Service Update

17259 OnStar Secondary Battery Input Feeding Current Back

Reference Number: N172098770

Release Date: June 2017

4825776

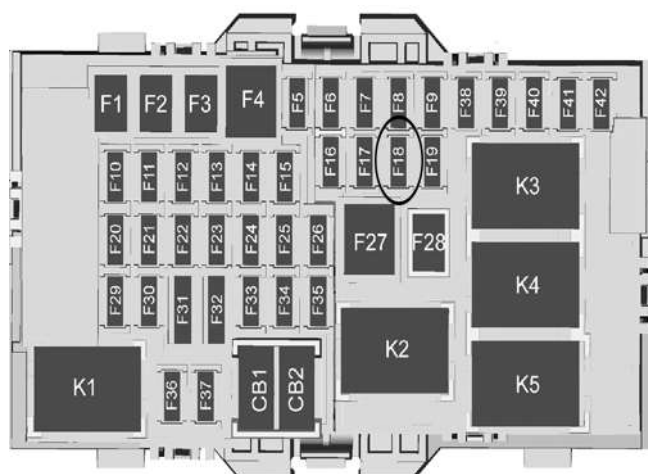
2. Remove and discard the instrument panel (IP) fuse F18 (this is a 5 amp fuse).
3. Install the instrument panel fuse block cover.
